P 44608
A REPAIR

SEWAGE DISPOSAL SYSTEM

HOWARD COUNTY
BUREAU OF ENVIRONMENTAL HEALTH
461-9933

SUBDIVISION _____ ROAD 3813 Ivory Road LOT _____

44608

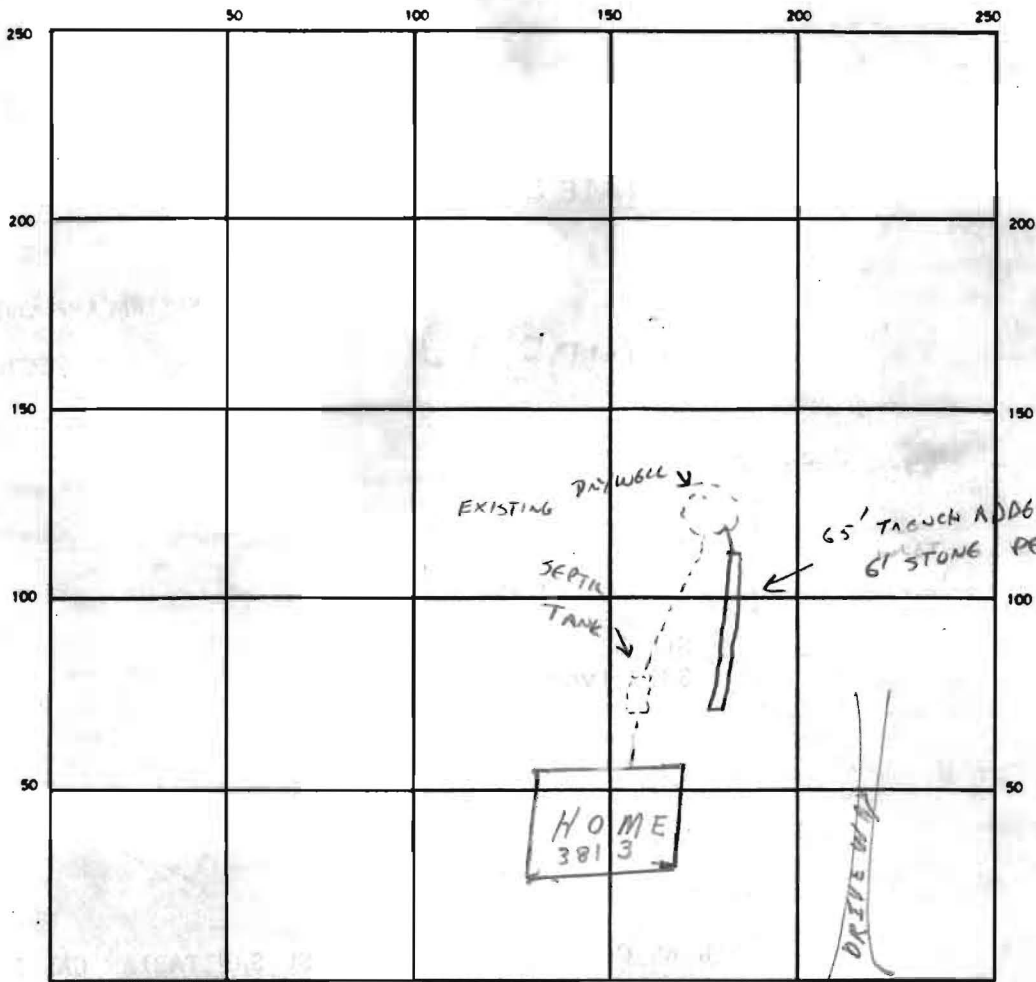
REMARKS 5/26/89 M. - OK TO CONTINUE; REPAIR IN PROGRESS

HOLD FOR CERTIFIED DRAWING; Left info with
FYOCK'S MEN. C.B.D.

5/26/89 CONTRACTOR'S SKETCH REVIEWED OK - SYSTEM APPROVED C. Wellian
